UNITED STATES PATENT AND TRADEMARK OFFICE

Office Action Summary

09/729,743

DETAILED ACTION***Information Disclosure Statement***

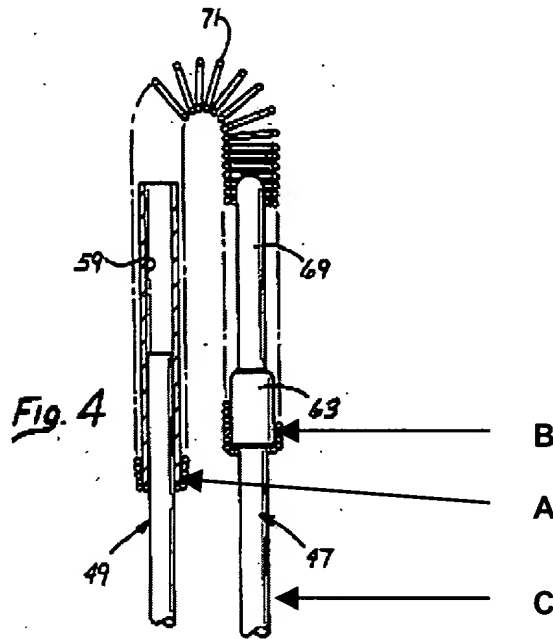
As to claim 19, Eppenbach discloses a connector module having:

a body **57**;

a resilient member **71** accommodating translational (compression of spring **71**) and rotational motion (bending of spring **71**) in more than one plane, the resilient member having a first end **A** connected to the body and a second end **B**;

a strut **47,63,69**, the strut having a first end **63,69** connected to the second end of the resilient member and a second end **C** for connection to another structural element (an identical connector module having a body **57**; Figures 2-5).

As to claim 20, Eppenbach discloses a connector module wherein another structural element comprises a second connector module (Figures 3 and 4).

As to claim 21, Eppenbach discloses a connector module wherein another structural element has a second strut (attached to a body **57** of the another structural element; Figures 3 and 4).

As to claim 25, Eppenbach discloses a connector module having a strut **47,63,69** having a telescoping member **69** (telescoping member **69** is telescopically received within cavity **59** of body **57**; Figures 3 and 4).

As to claim 38, Eppenbach discloses a connector module having a resilient member **71** accommodating axial motion (Figures 4).

a resilient member **71** accommodating translational (compression of spring **71**) and rotational motion (bending of spring **71**) in more than one plane, the resilient member having a first end **A** connected to the body and a second end **B**;

a strut **47,63,69**, the strut having a first end **63,69** connected to the second end of the resilient member and a second end **C** for connection to another structural element (Figures 2-5).

As to claim 64, Eppenbach discloses a structure having an adjustable shape defined by connections between a second end **C** of a strut **47,63,69** and another structural element and a position of the resilient member **71** of a connector module (Figures 5 and 6).

As to claim 65, Eppenbach discloses a structure which is collapsible (Figure 5).

As to claim 84, Eppenbach discloses a structure assuming a plurality of shapes determined by relative positions of the resilient member **71** and the telescoping strut **47,63,69** of each of a plurality of connector modules (Figures 3 and 4).

As to claim 85, Eppenbach discloses a structure assuming a first shape in two dimensions and a second shape in three dimensions (Figures 5 and 6).
